DART AEROSPACE LTD HAWKESBURY, ONTARIO, CANADA	
DRAWING NO. D3290	REV. C SHEET 1 OF 2
TITLE REPLACEMENT WINDOW ASSEMBLY	
SCALE 1:5

DRAWING NO. D3290	TITLE REPLACEMENT WINDOW ASSEMBLY	REV. C	DART AEROSPACE LTD ENGINEERING ORDER		D.E.O. NO. D3290-C-1	SHEET NO. SHEET 1 OF 1	SCALE NTS
DRAWN <i>q</i>	CHECKED <i>h</i>	MFG. APPR. <i>E</i>	APPROVED <i>MP</i>		DE APPR. <i>h</i>		
DATE 09.09.18	DATE 09.09.18	DATE 09.09.18	DATE 09/09/21		DATE 09/09/21

CHANGE MATERIAL THICKNESS OF D3290-1 FRAME TO 0.063 FROM 0.040. REF PAR 09-033.

D3290-1 FRAME

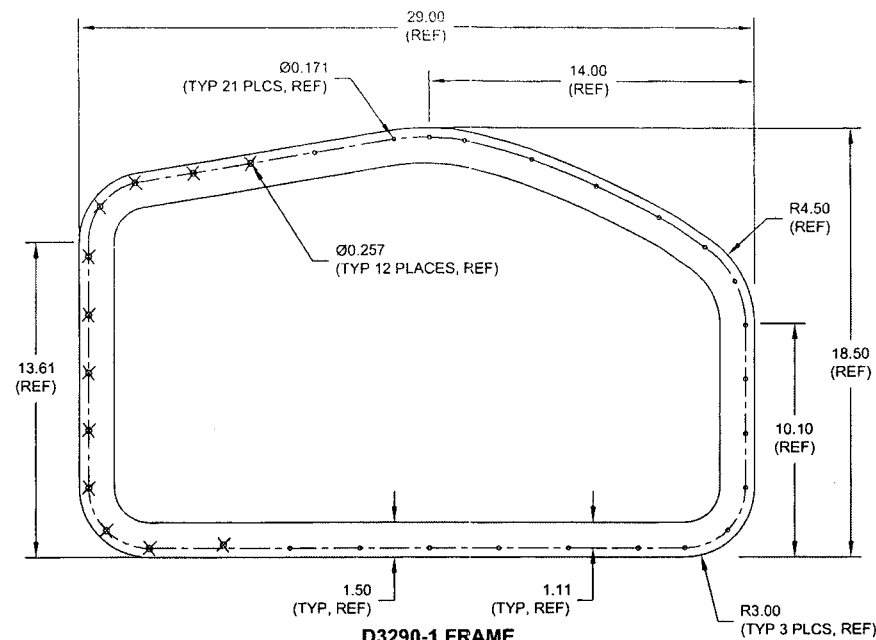
MATERIAL CALL-OUT OF D3290-1 FRAME ON SHEET 1 IS AMENDED AS FOLLOWS:

- 1) MATERIAL: 6061-T6 (OR 6061-T62) ALUMINUM SHEET ~~0.040 THICK~~ 0.063 THICK (REPLACE)
 PER AMS-QQ-A-250/11 OR AMS 4025 OR AMS 4027
~~(REF. DART SPEC. M6061T6S.040)~~ REF. DART SPEC. M6061T6S.063 (REPLACE)
 OR
 5052-H32 ALUMINUM SHEET ~~0.040 THICK~~ 0.063 THICK (REPLACE)
 PER AMS-QQ-A-250/8 OR AMS 4016
~~(REF. DART SPEC. M5052H32S.040)~~ REF. DART SPEC. M5052H32S.063 (REPLACE)
